Torque Rod Replacement
CHU, CXU, GU, TD

FSB 652-004, Torque Rod Replacement

(March 2012)

Torque rod on front rear axle makes contact with carrier during articulation. The following
procedure must be performed on the front and rear torque rod at the same time.
This applies to MACK axles only. This bulletin applies to vehicles equipped with HH and
HN suspensions only.

W6070237

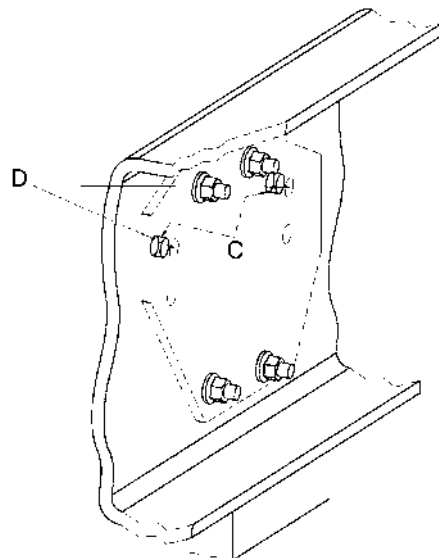
Assemble the new parts (inner and outer plates) onto the frame rail where the torque rod will be re-installed. Tighten the fasteners to 200 ± 30 Nm (148 ± 22 ft-lb).

W6070238

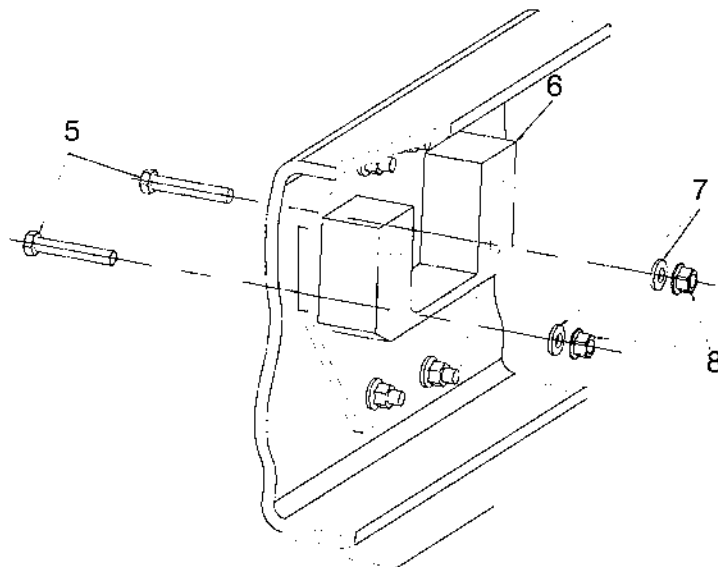
Note: Prior to drilling new holes in frame ensure that all six existing holes in frame line up with holes in new reinforcement plates. Then, use reinforcement plate holes "D" as guide to drill holes "C" in frame as directed below. Failure to do so will result in frame rail damage requiring frame rail replacement.

Drill two new 17 mm (0.67 in.) holes in the frame rail using the holes in the plate installed in the previous step as a guide.

W6070239

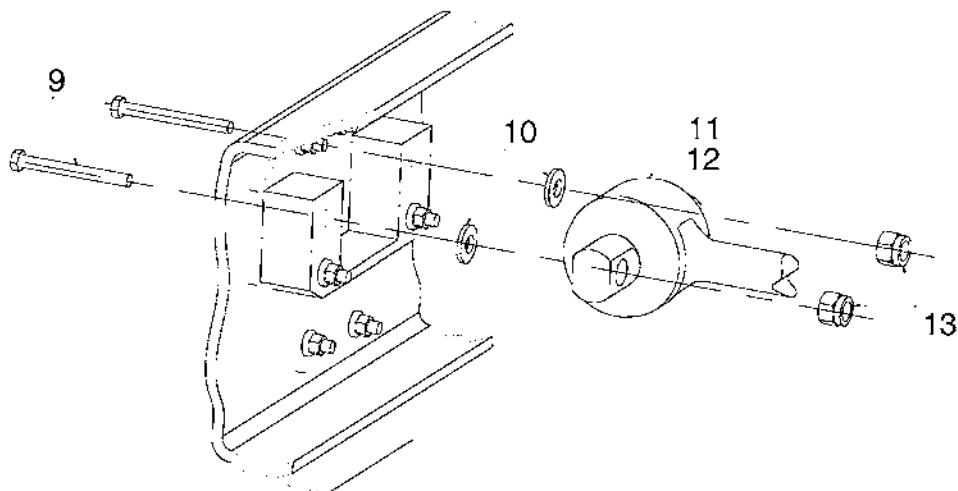
Install the new torque rod bracket and fasteners. Tighten the fasteners to 610–813 Nm (450 – 600 ft-lb).

W6070240

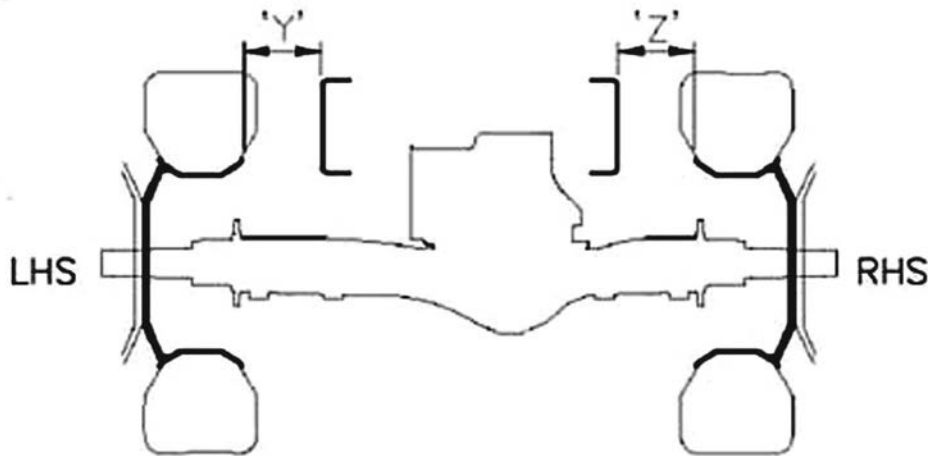
Connect the torque rod to the new holes on the frame rail torque rod bracket and tighten to specification 610–813 Nm (450 – 600 ft-lb).
